## CSP 25-056 AL BP041 – ADDENDUM No.01 HVAC MEP EAST ZONE 3

Fort Bend Independent School District  
2023 Bond Program

Addendum 01

13 August 2025

JS-M2.00

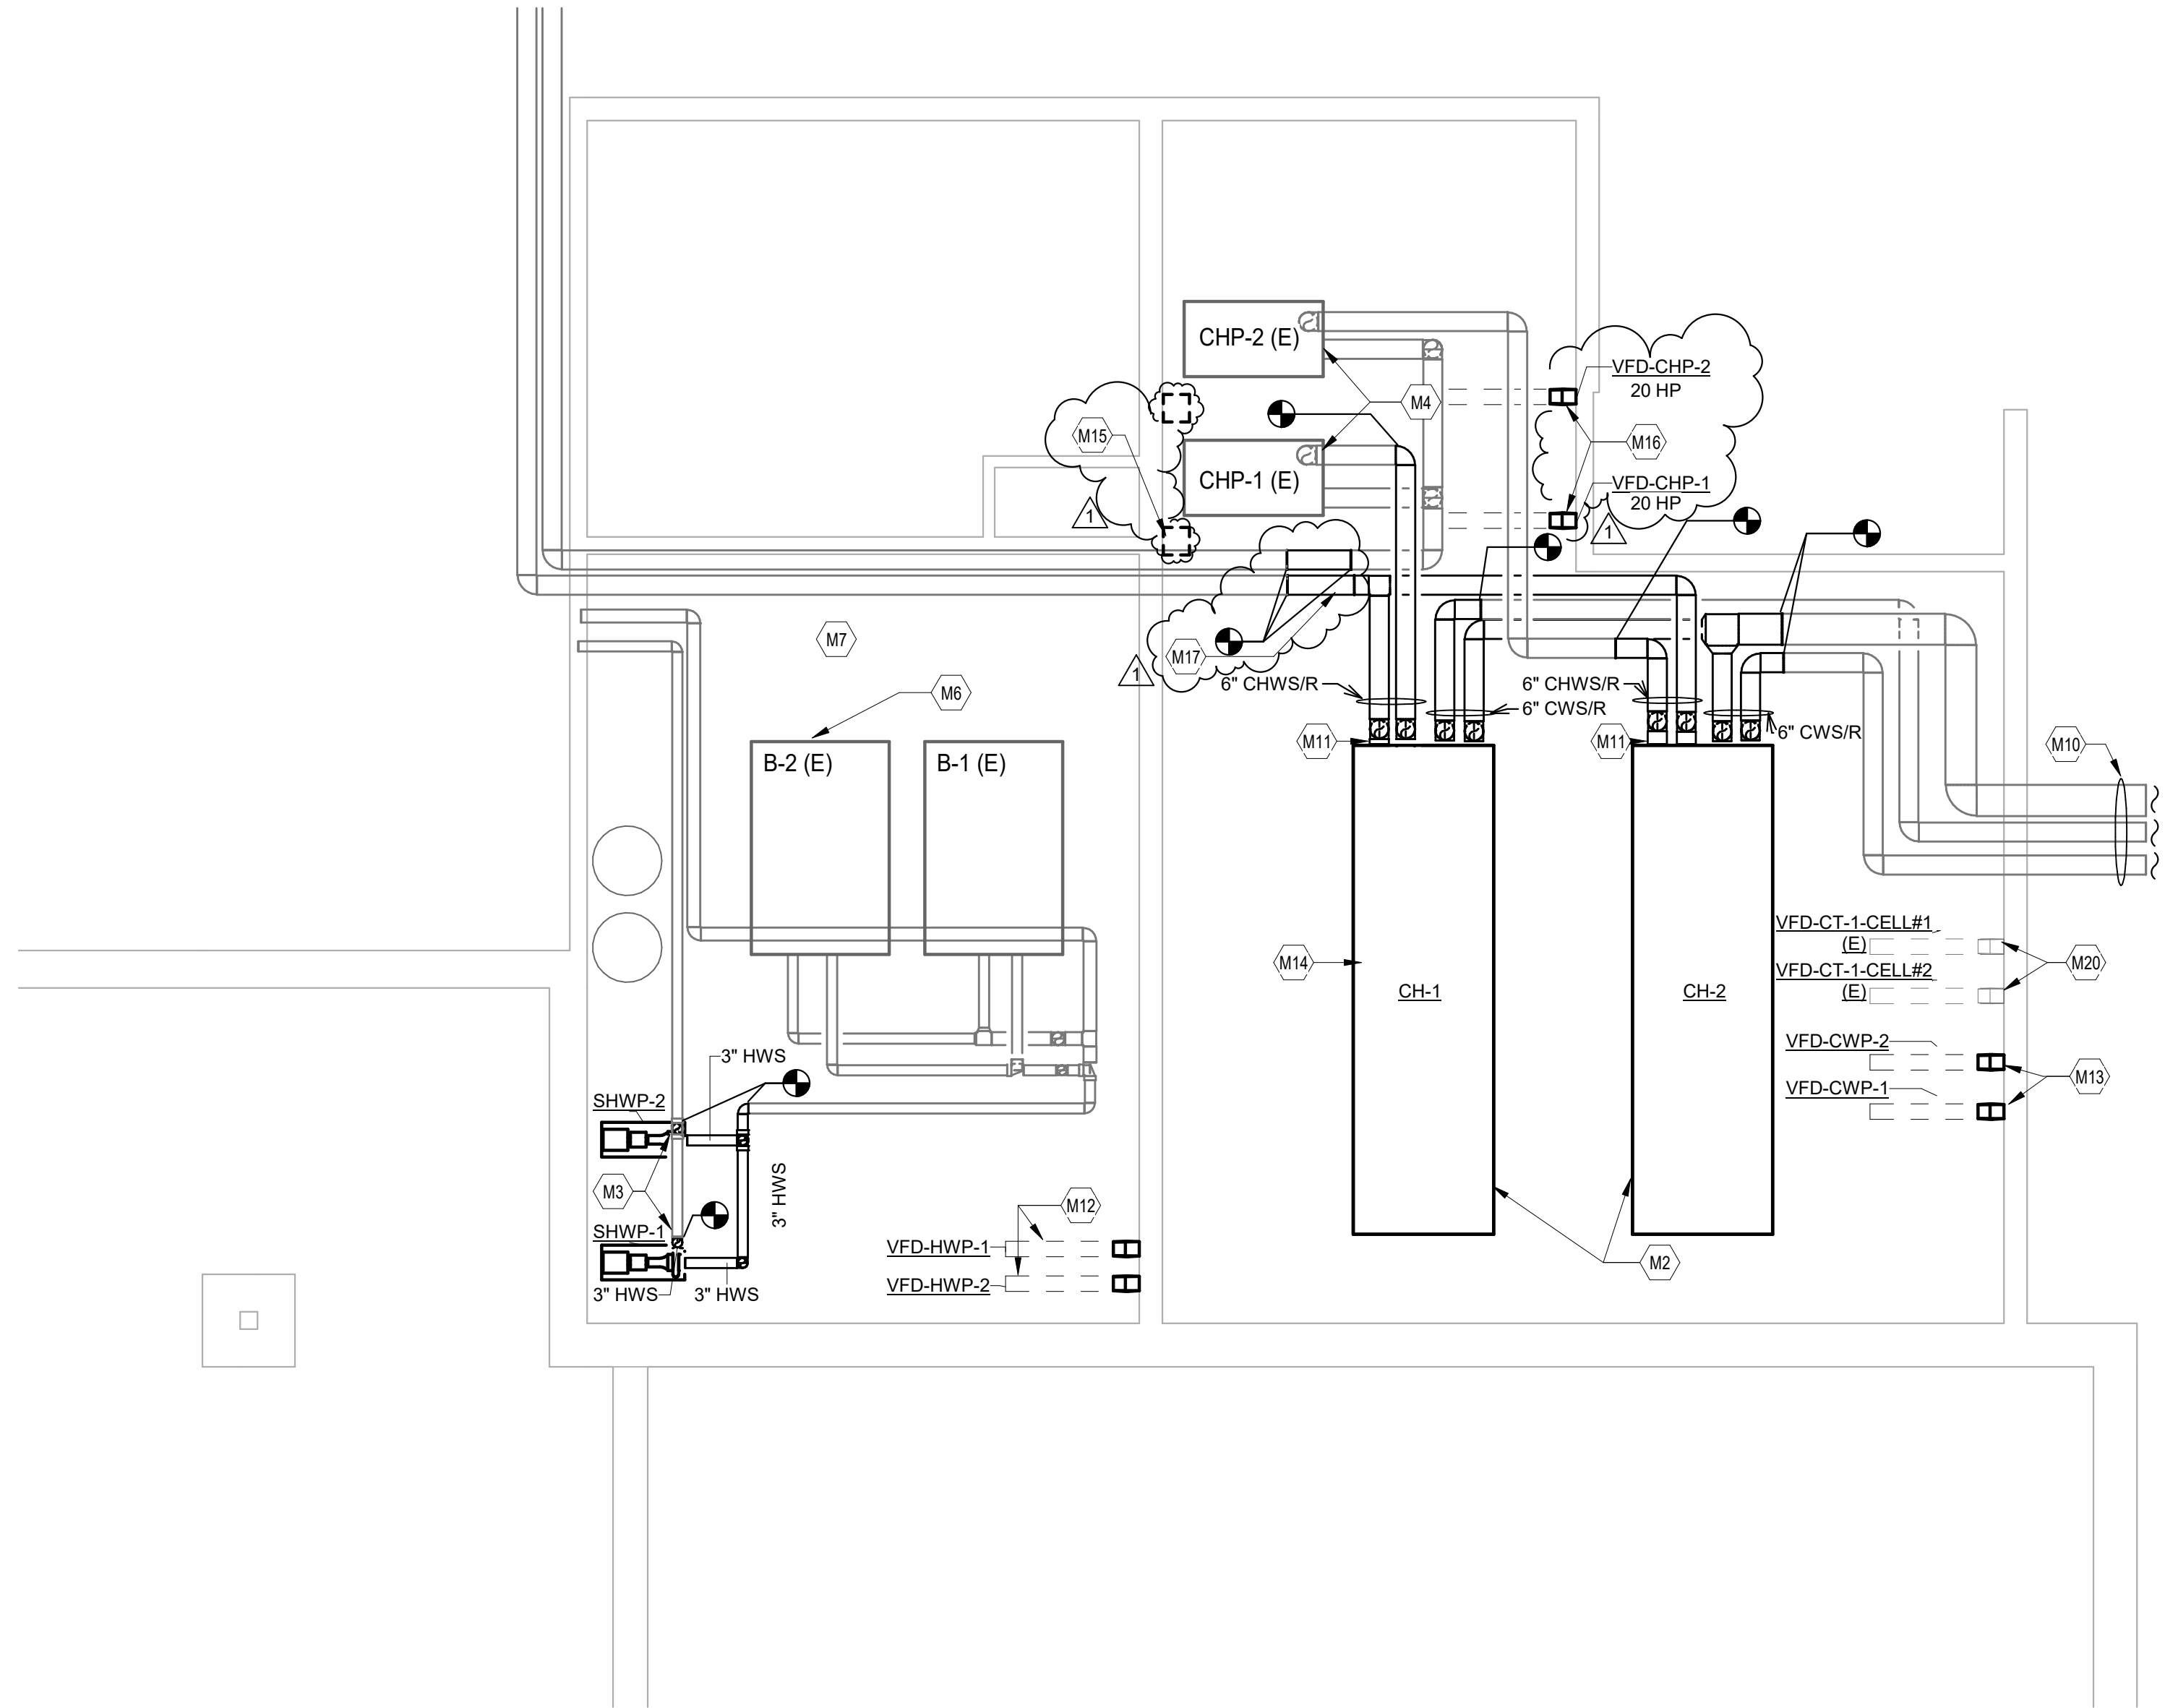
- 06 **Sheet SC-M3.02– ENLARGED PLANS**
  - a. Added future tap offs for chilled water piping in renovation.
- 07 **Sheet JS-M2.00– MECHANICAL OVERALL**
  - a. Bypass relocated to this sheet

JS-M2.01

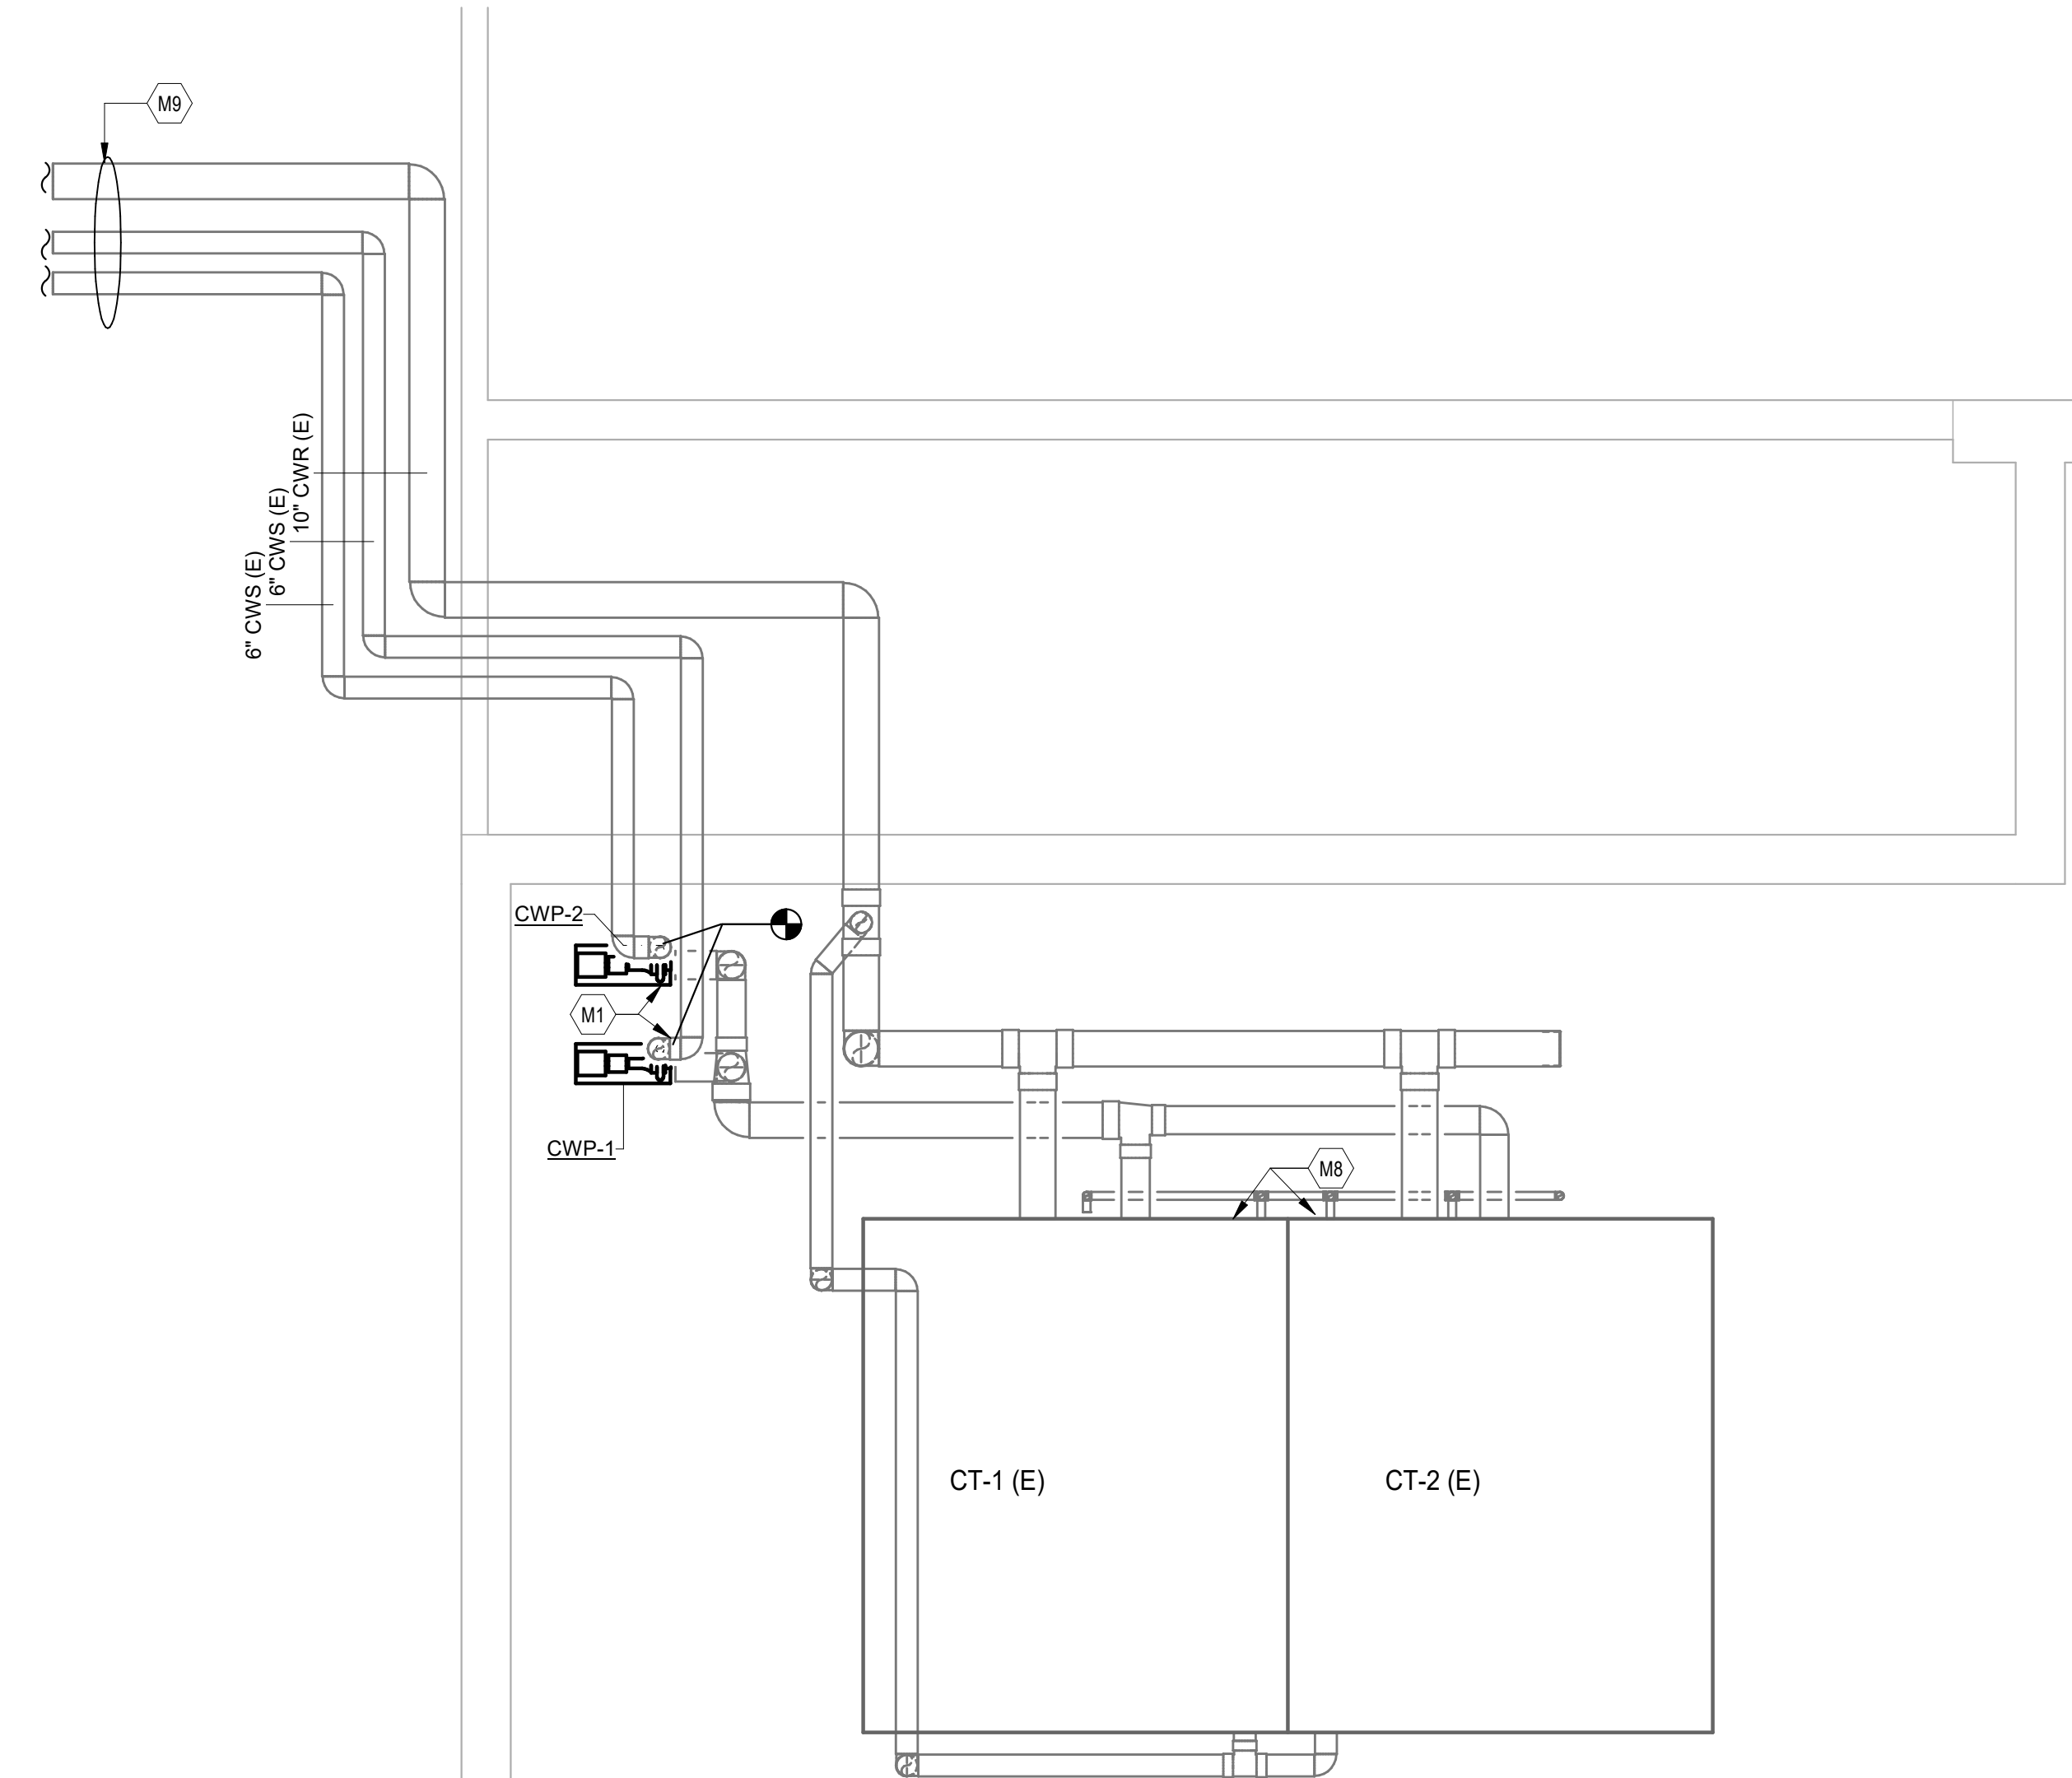
- 08 **Sheet JS-M2.01– MECHANICAL CENTRAL PLANT**
  - a. Called to remove two (2) existing CHP pump disconnects. Added one 20 HP VFD for each of two disconnects in a new location.

- b. Removed chilled water bypass. Bypass to be relocated on JS-M2-00.
- 09 **Sheet SO-M2.00 – MECHANICAL – NORTH**
  - a. Separated hydronic duct heater into separate schedule. Added manufacturer and equipment model of duct heater.

REMOVE PIPING TO EXISTING ISOLATION VALVE AND REPIPE.

EXISTING HEAD PRESSURE CONTROL VALVE TO BE REPLACED WITH NEW.

REPLACE CHILLED WATER PIPING FROM ISOLATION VALVE TO PUMPS INCLUDING ISOLATION VALVES. TYPICAL OF TWO.
